E3631A-13B**S E R V I C E****N O T E**Supersedes:
E3631A-13A**E3631A DC Power Supply****Serial Numbers: MY51240260 to MY99999999****Metal Strap Kit for tightening loose bumper and for fitting rear lock link in side-by-side rack mounting****Parts Required:**

March 27, 2013

Figure 1: Top view 3mm gap observed between two different chassis designs

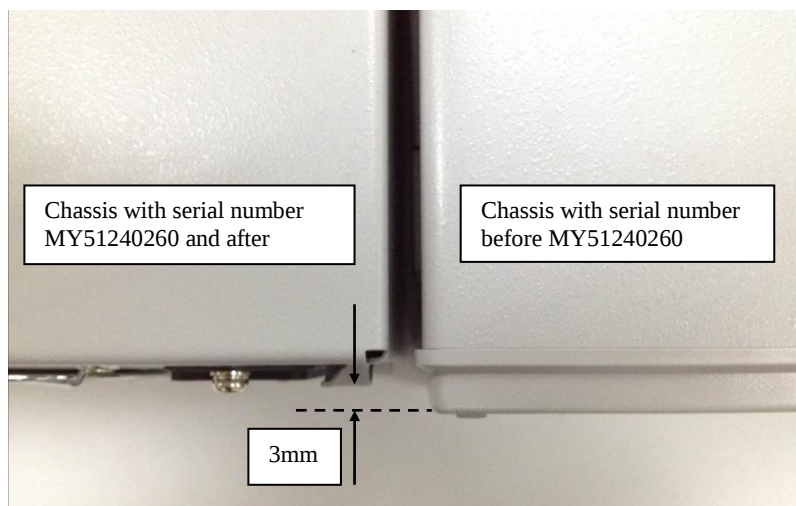
Situation 2:

The chassis depth difference between the two designs is 3mm as shown in Table 1 and Figure 1 below.

Figure 2: Top view 3mm gap observed on rear lock link for side-by-side rack mounting

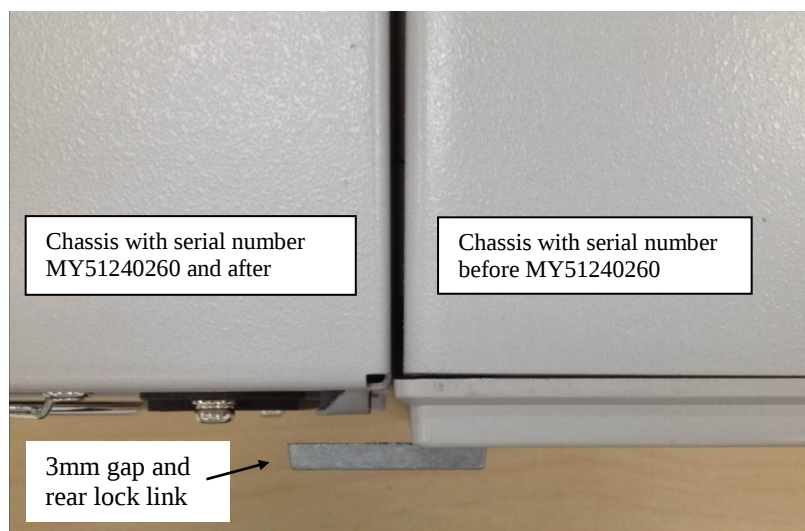
The 3 mm gap between the two different chassis may cause difficulties in securing them together using a rear lock link kit (part number 0050-2167) for side-by-side rack mounting as shown in Figure 2 below.

Solution for Situation 2

Use metal strap (part number E3631-07901), and stack the provided two metal straps together to form 3mm thickness and secure it with the provided screws on the rear lock link as shown in Figure 4 below.
